CITY OF CODY  
PLANNING, ZONING AND ADJUSTMENT BOARD  
TUESDAY, NOVEMBER 13, 2018  
CITY HALL COUNCIL CHAMBERS @ 12:00 NOON

<b>MEETING DATE:</b>	NOVEMBER 13, 2017	<b>TYPE OF ACTION NEEDED</b>	
<b>AGENDA ITEM:</b>		P&Z BOARD APPROVAL:	X
<b>SUBJECT:</b>	SITE PLAN REVIEW: EAGLE RECOVERY REPAIR SHOP AND STORAGE YARD. SPR 2018-22	RECOMMENDATION TO COUNCIL:	
<b>PREPARED BY:</b>	TODD STOWELL, CITY PLANNER	DISCUSSION ONLY:

# THE EAGLE RECOVERY SHOP

SHEET #  
**E1.0**  
MAIN ELEC.

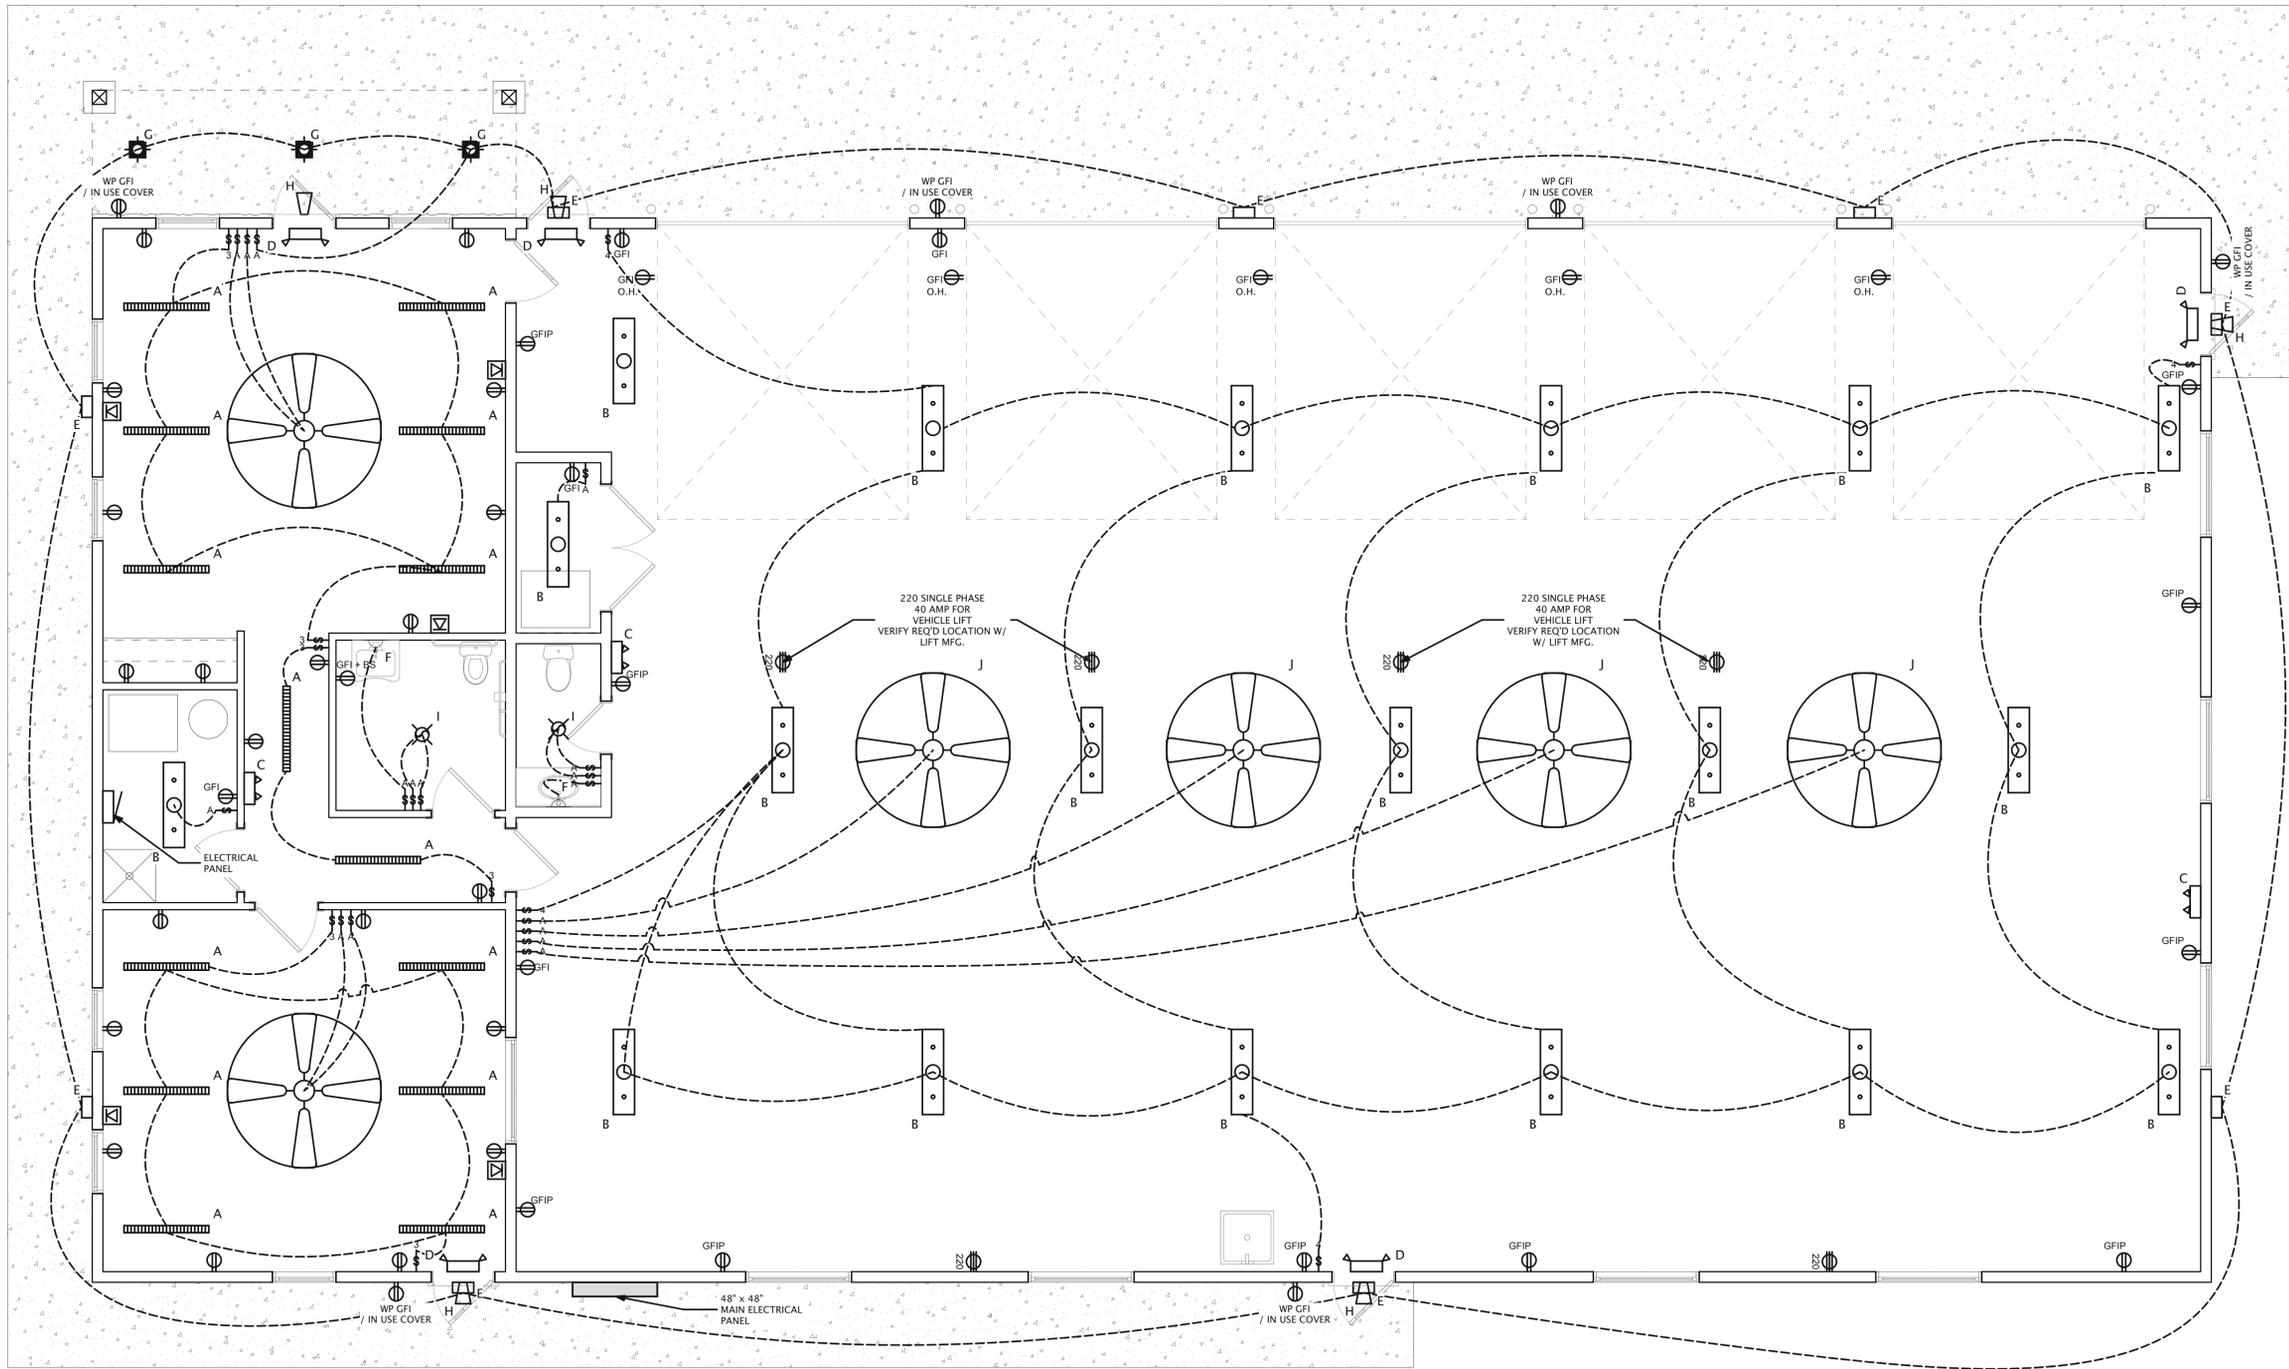
The exterior lighting details are included on Sheet E1.0. You will see fixtures "E", "G" and "H". Fixture "G" area simply the recessed can lights in the entry porch, and Fixture "H" is an emergency batter pack light, only illuminated when power is disrupted. Fixture E is a full cutoff LED wall pack, that comes in different illumination levels ranging from 7,500 to 12,000 lumens and different distribution patterns. 7,500 lumens is equivalent to about 450 watts of incandescent light and 12,000 lumens approximately 750 watts of incandescent light. The proposed lighting levels or patterns are not specified in the application. The applicant will be asked to provide detail for the meeting.

The applicant may want to reconsider whether the large wallpacks are necessary along the south and west sides of the building, or if less intense fixtures would be sufficient. If the wallpacks are used there they should have a wide pattern (Type II) and be of the lowest wattage, where the fixtures on the north and east sides of the building should probably have a forward throw pattern.
